-Fourth Street-  
-Cedar Avenue-  
-Lockett Road-  
Roundabout

June 7, 2022

# Fourth/Cedar/Lockett Roundabout

## Update on Design Requests

**Fig. 2** Rectangular Rapid Flashing Beacon (RRFB) at Crossing Martin Luther King Roundabout, Springfield, OR

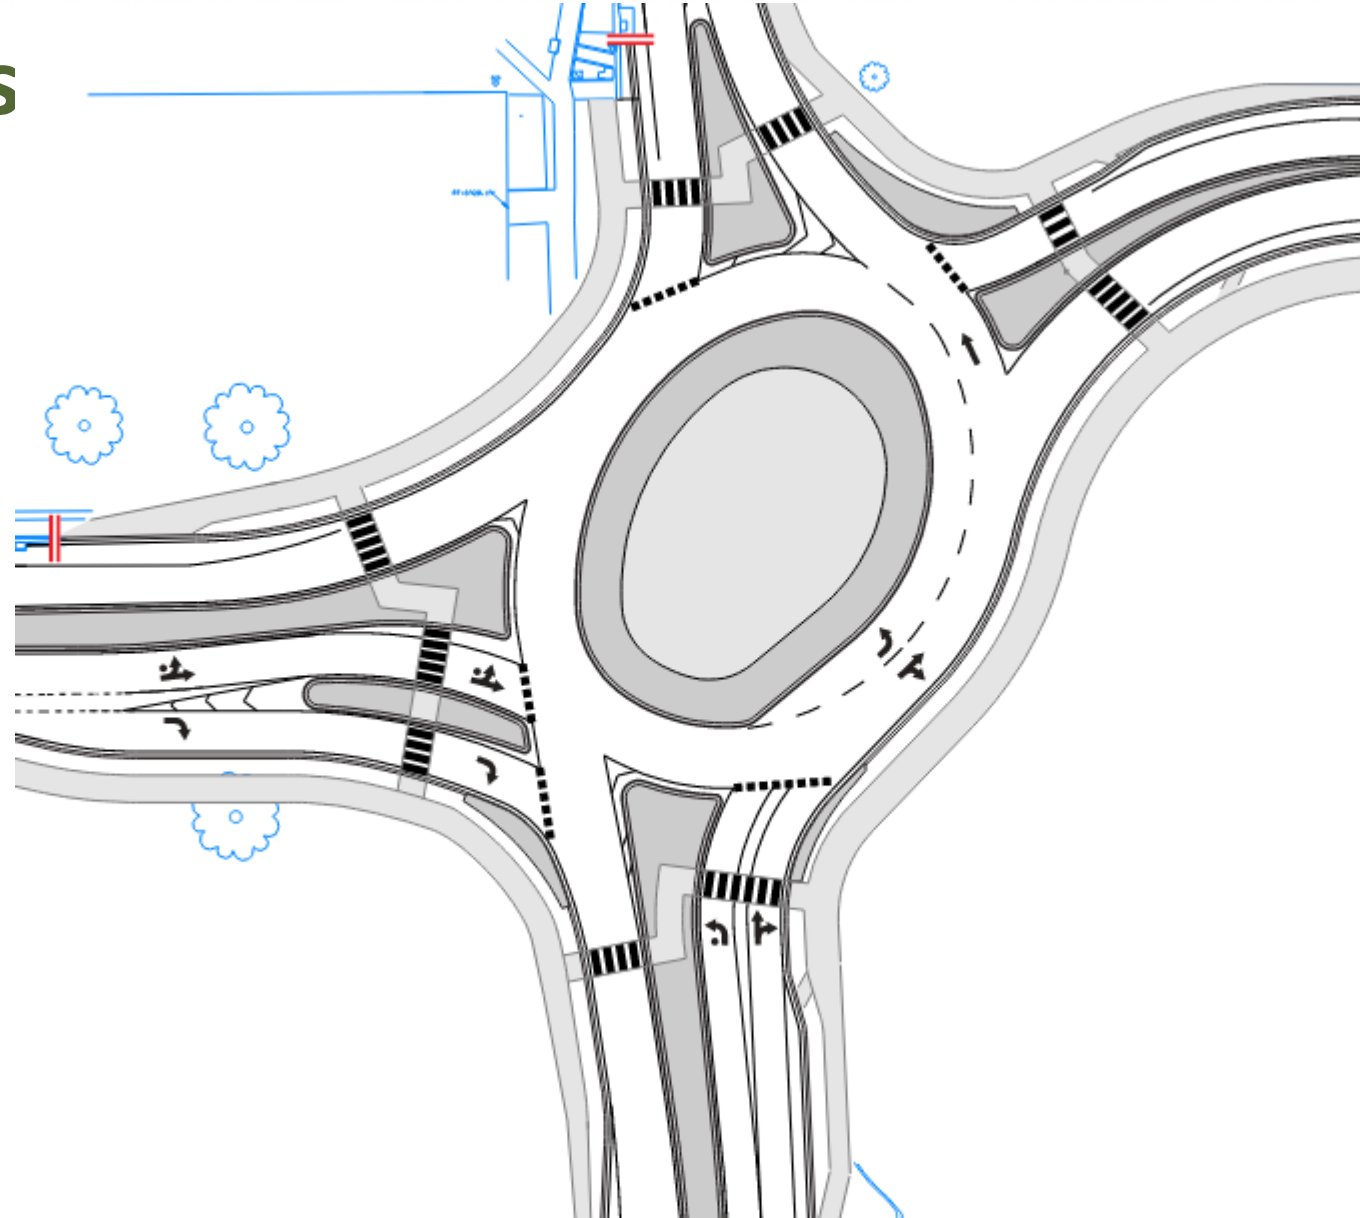
- Request: Pedestrian Actuated Rapid Flashing Beacons at all crossings
- Schedule Impact: None
- Construction Cost: \$400,000

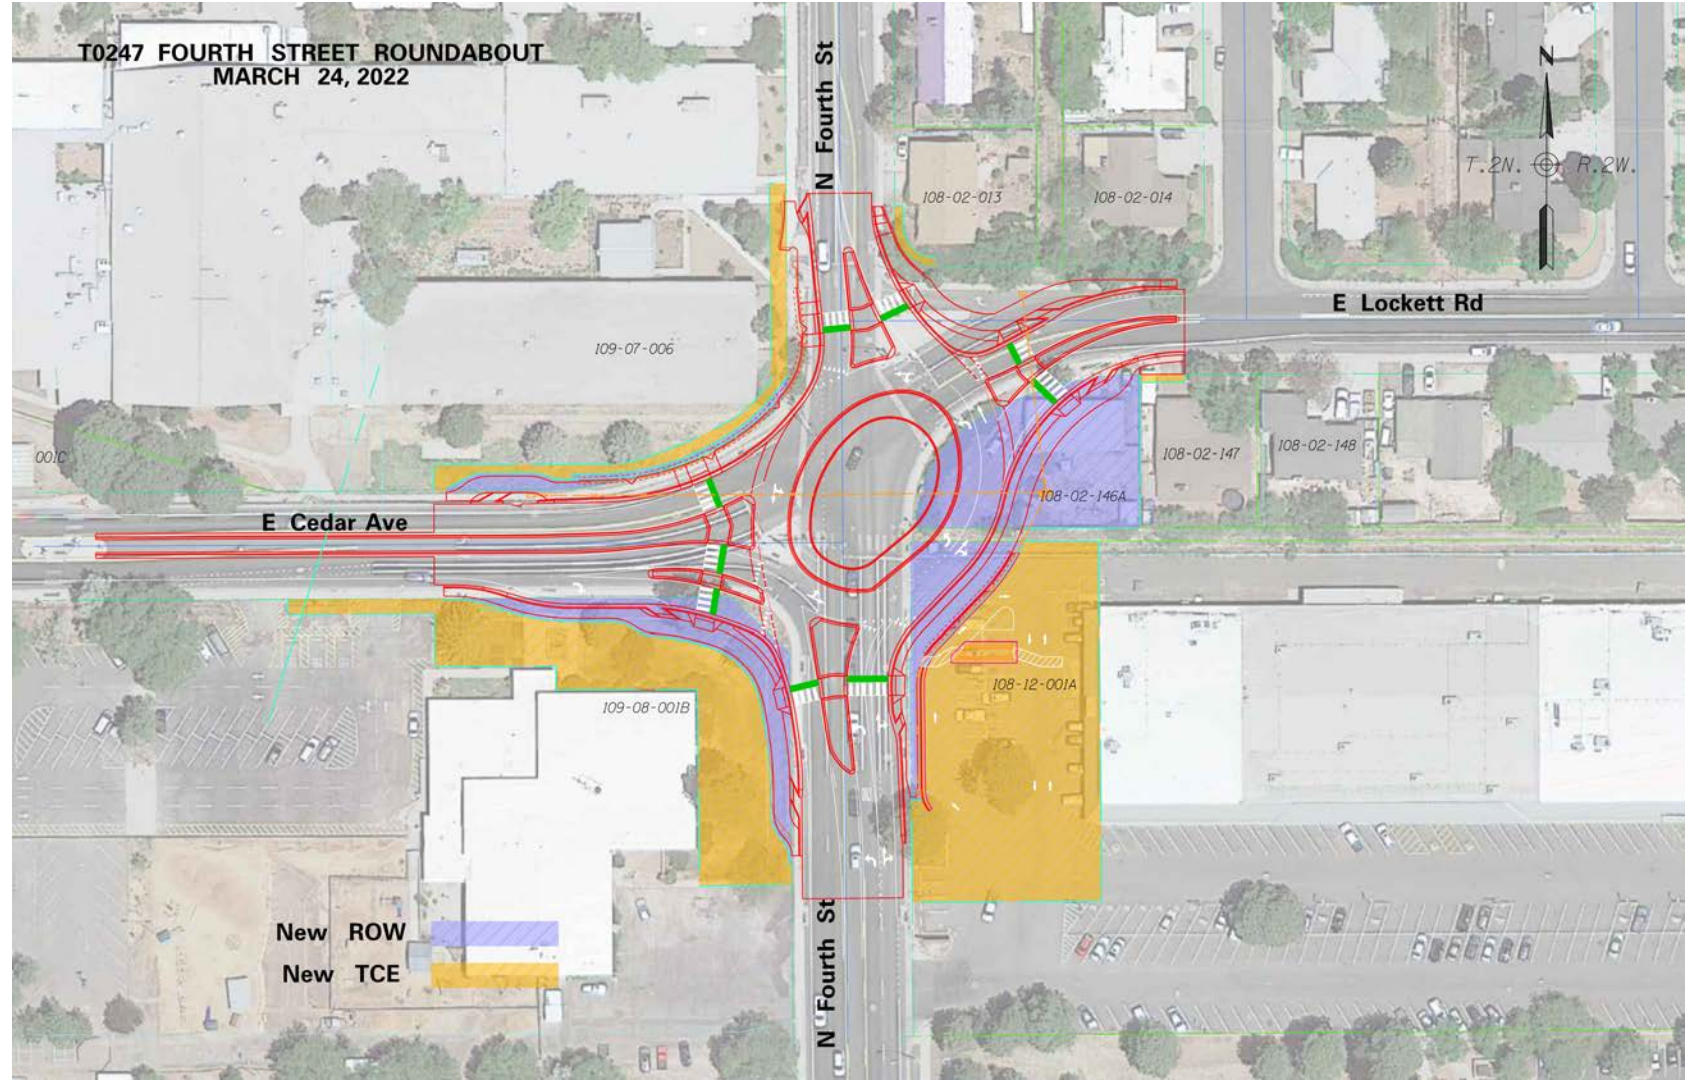
- Request: Elevated/Raised Crosswalks
- Not recommended due to drainage impacts and operational and maintenance considerations

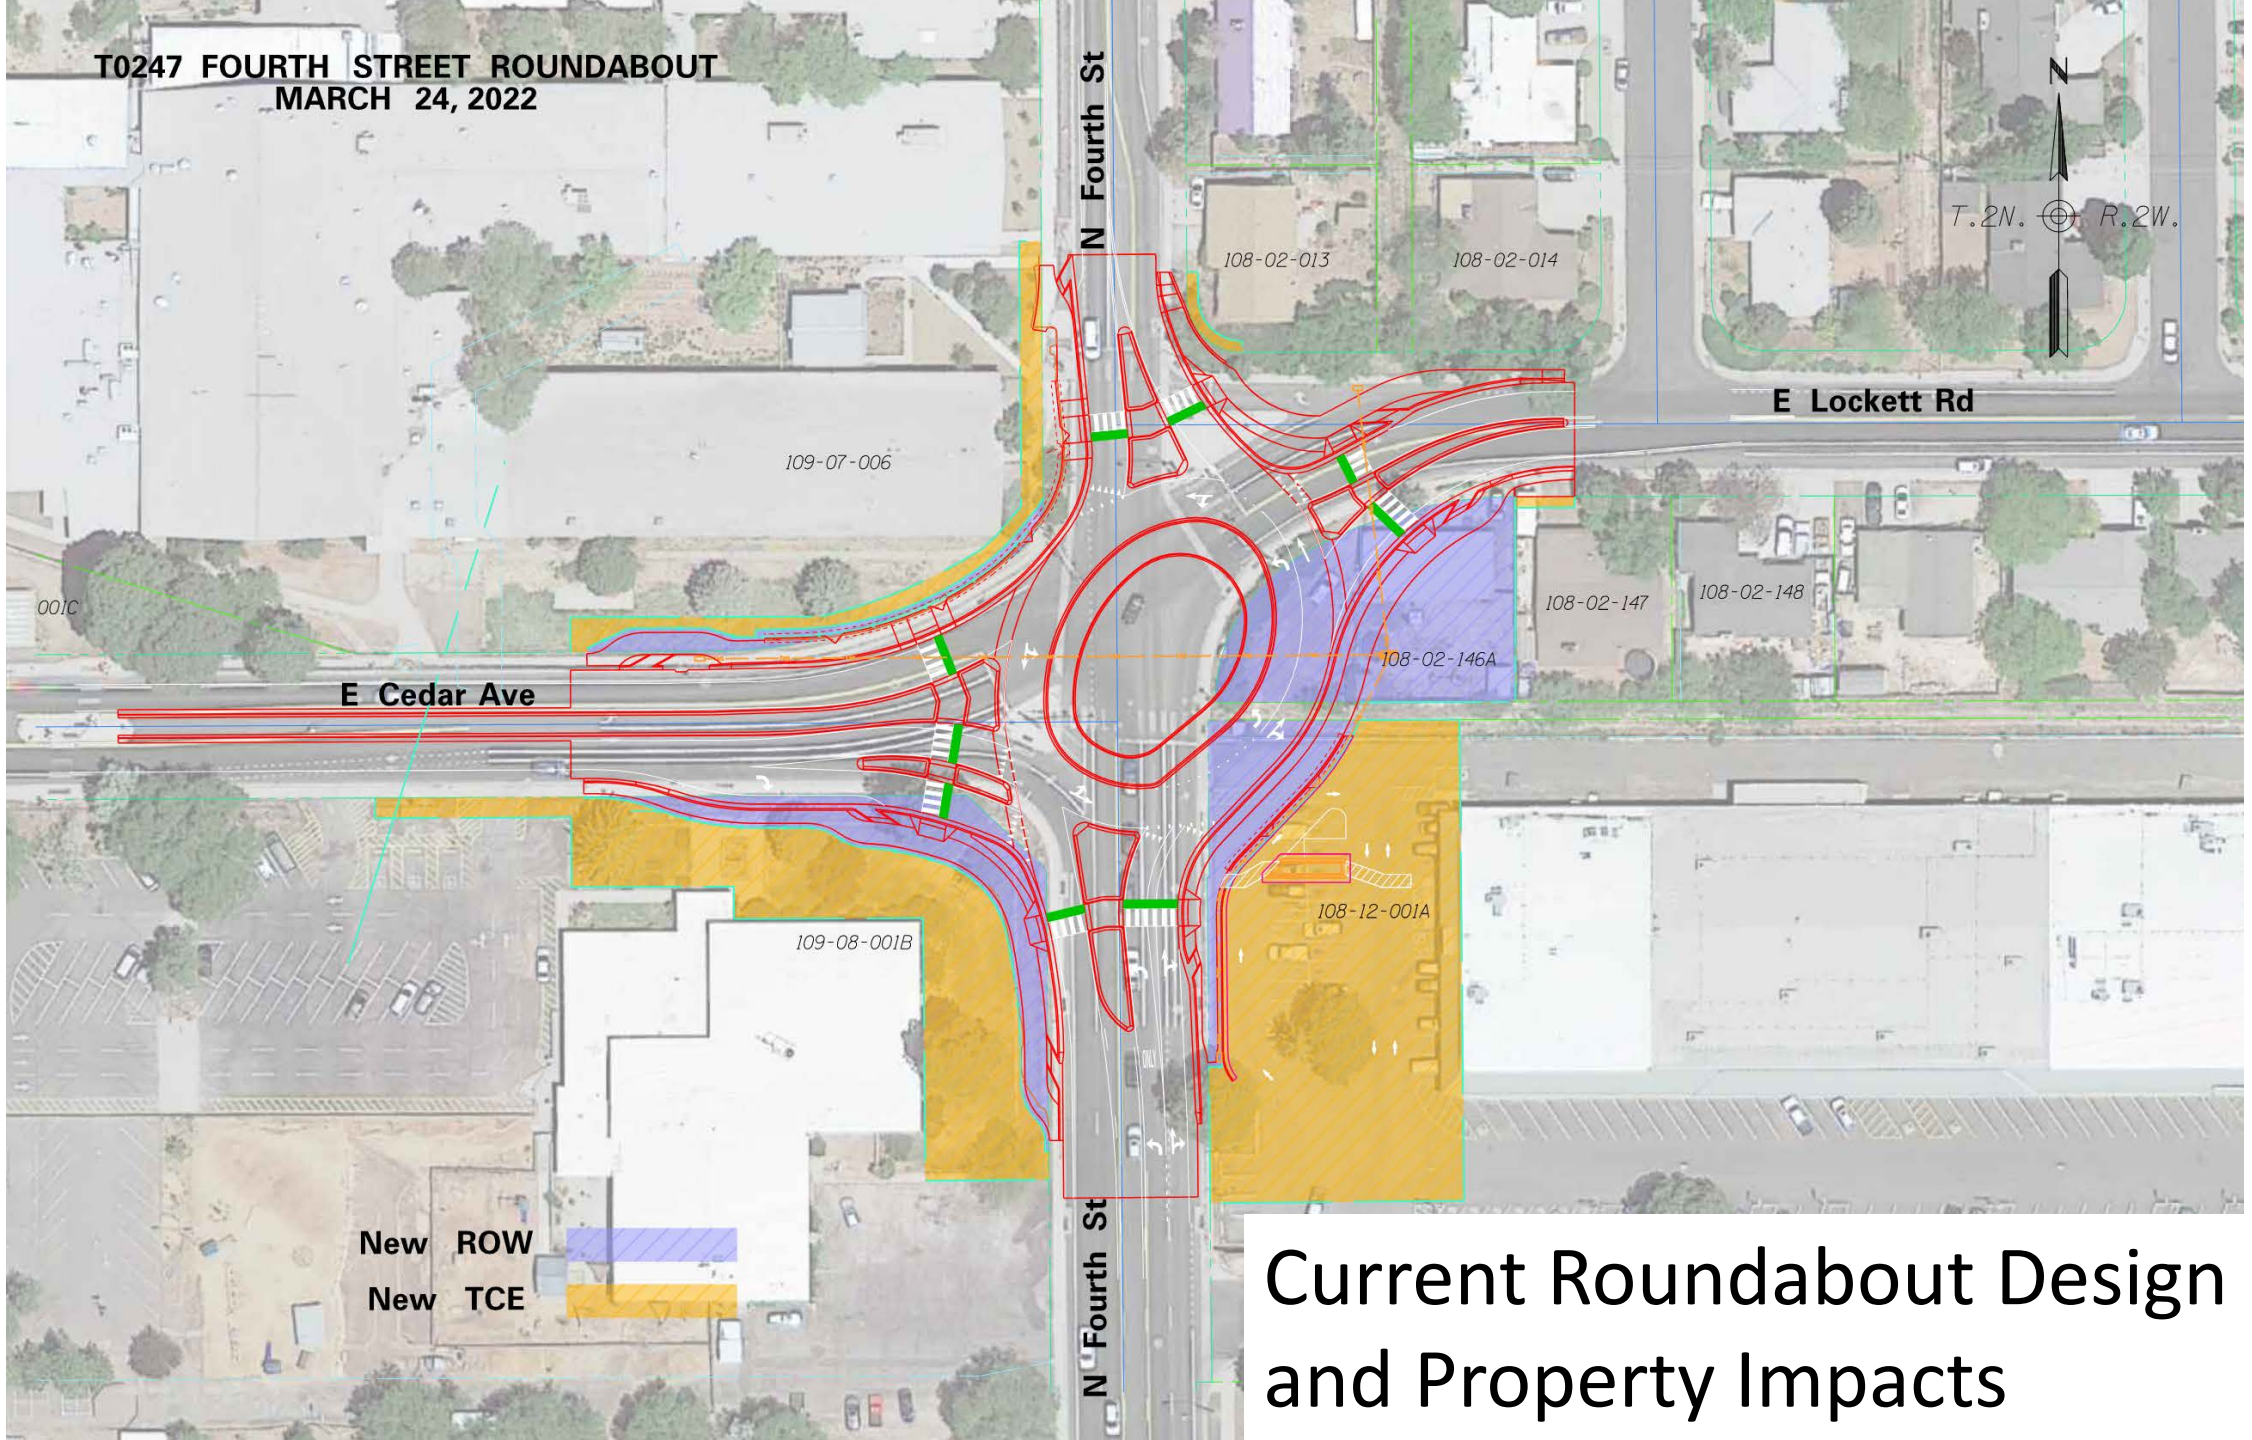
- Additional Design costs: \$75,000-\$100,000
- Schedule Impacts: Acquisition schedule remains the critical path
